Some notes on the Barwon Heads Structure Plan December 2007.

What follows are pages of the Structure Plan with all the Motions passed by the Barwon Heads Association on the 19th September (bounded by thick black lines) pasted into the relevant pages of the Plan,. There are numbers assigned to each of the 'Directions' embedded in the Plan and then the Motions are correspondingly numbered.

COPY OF LETTER TO COUNCIL

Map 10 - Significant Landscape and Environmental Features

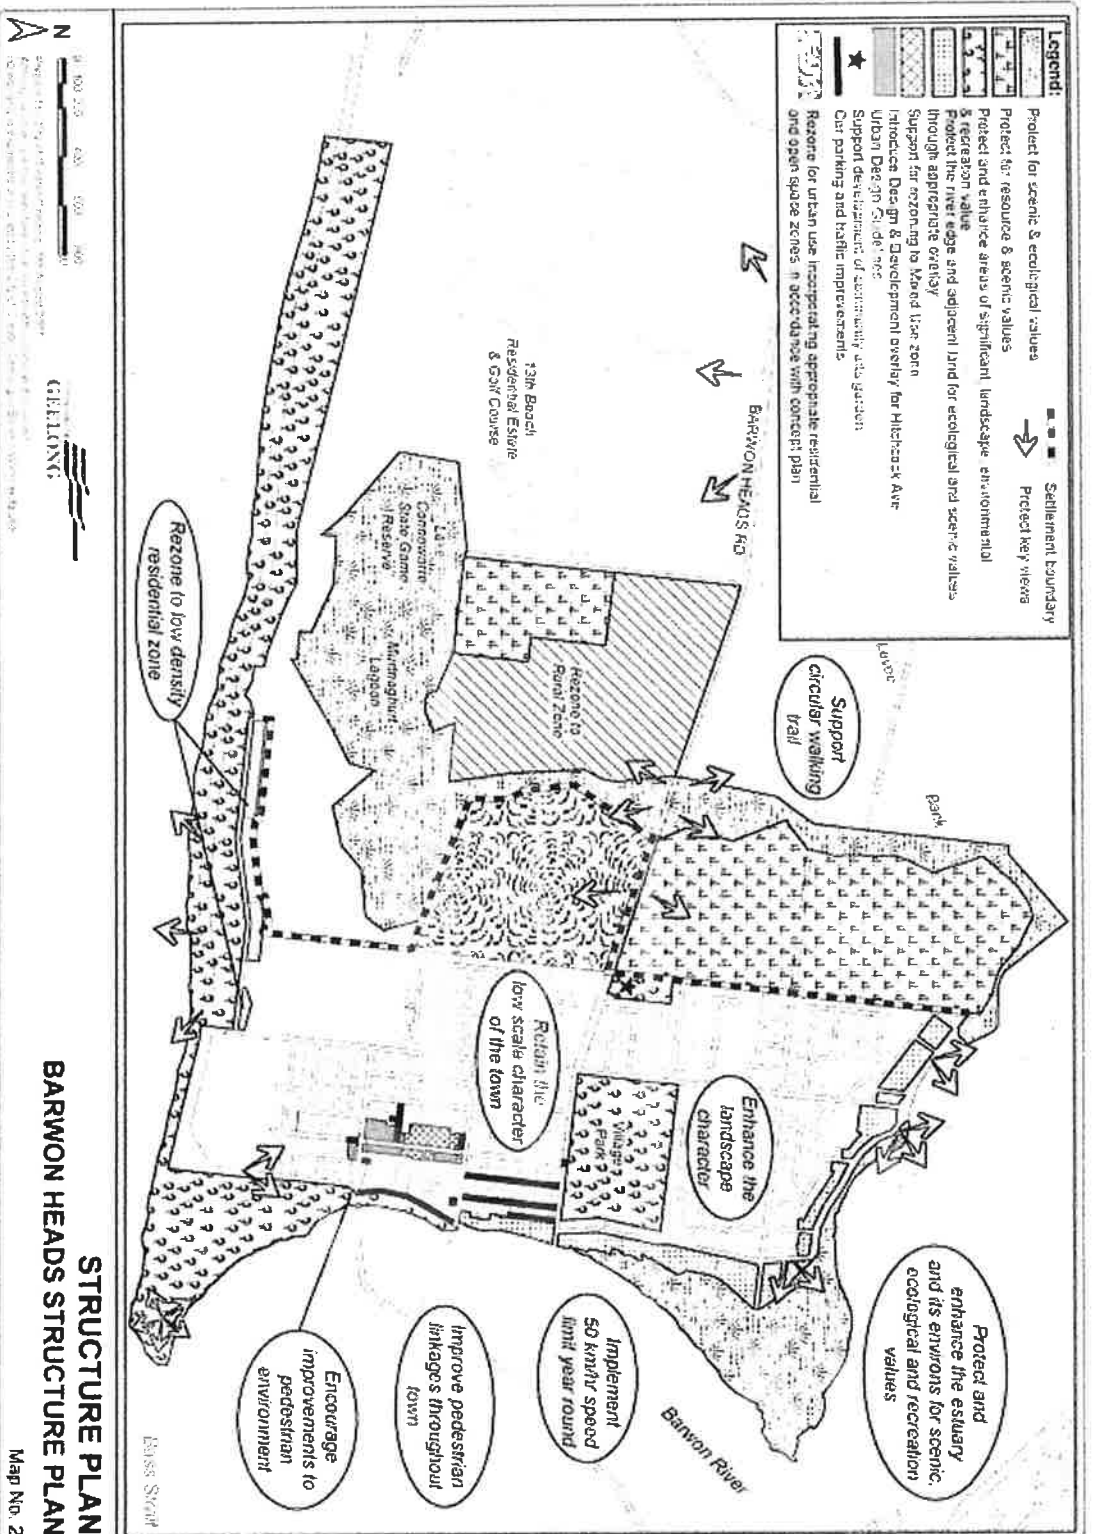
- Page 79** **The map in the December Plan is very different from the same page map in the July Plan. Of particular note is the new "Settlement boundary" in the December Plan.**
